工程指示 / 要求簡箋(E.I.)

工程指示編號：EI / 8952 / 25 修改版次： A

工程編號： J - 858 工程名稱：將軍澳日出康城

工程項目：幕牆 第 2 次 補玻璃 31 件 (小業主單)

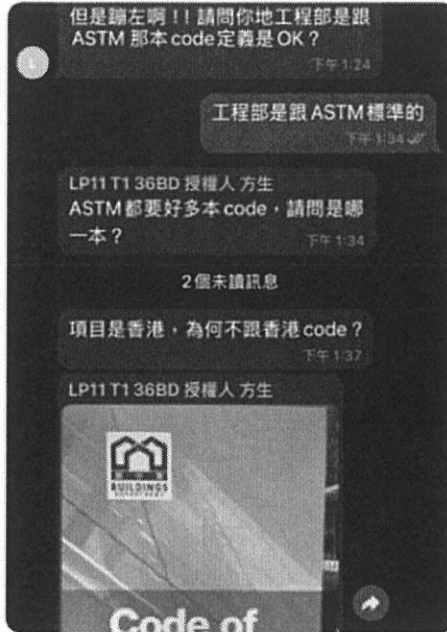
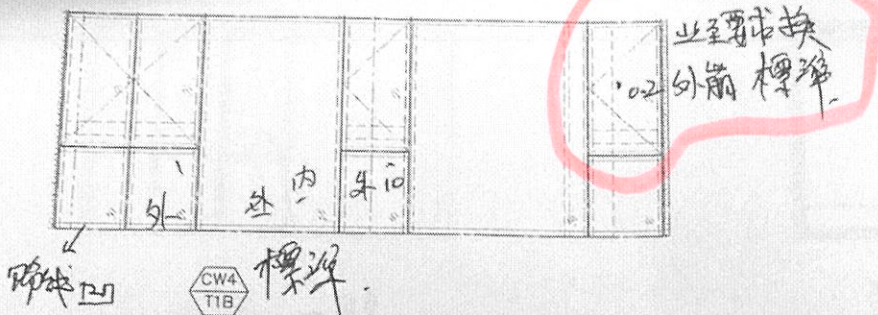
36BD 客話主房右生窗驗樓師寫住換，
佢問係打磨咗定要換？

36BD個客唔接受

@jason leung @Midi向玉芳
36BD個客唔接受

照訂玻璃

城11期凱柏峰
 站窗，鋁門及幕牆玻璃的驗收表格

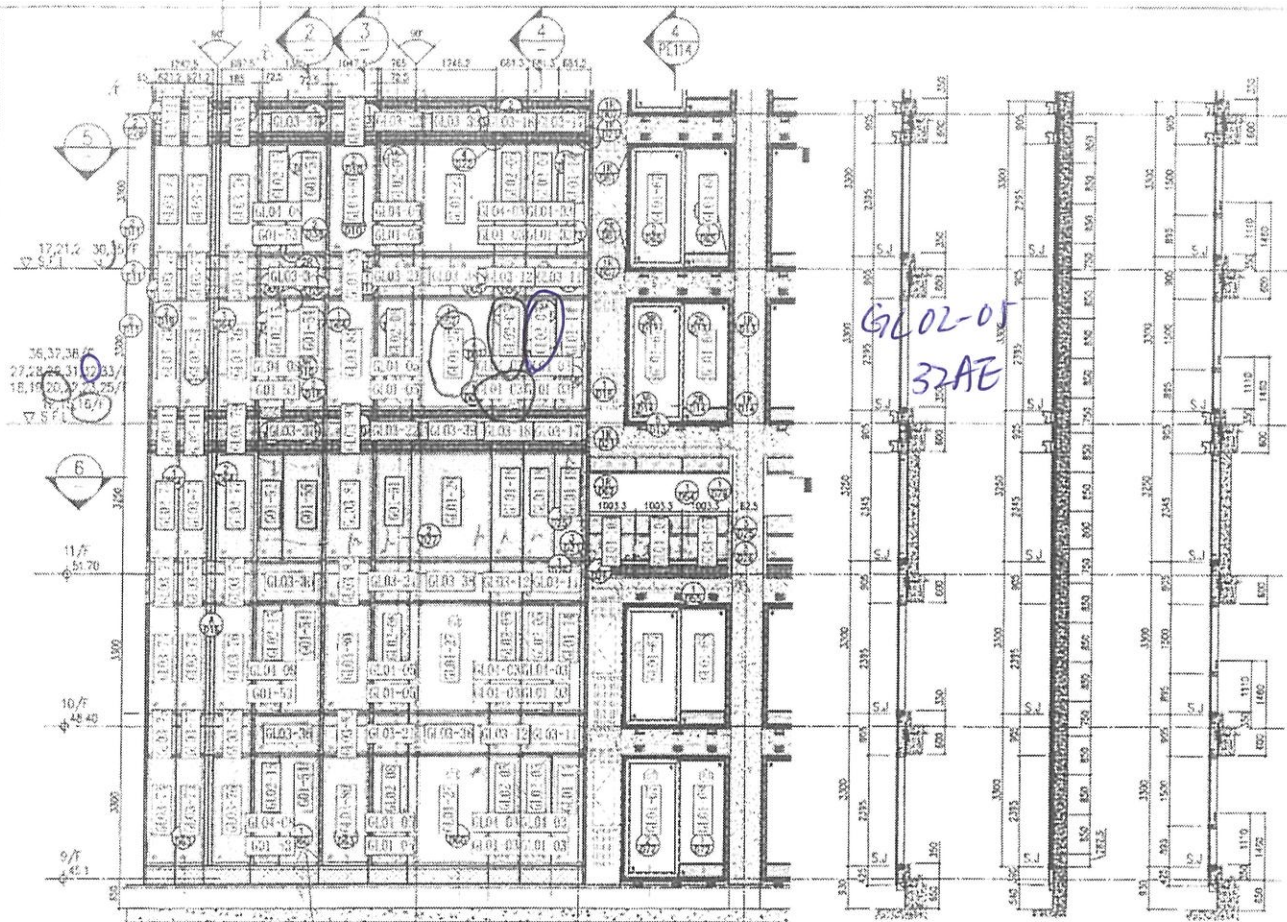
36BD-主房右生窗
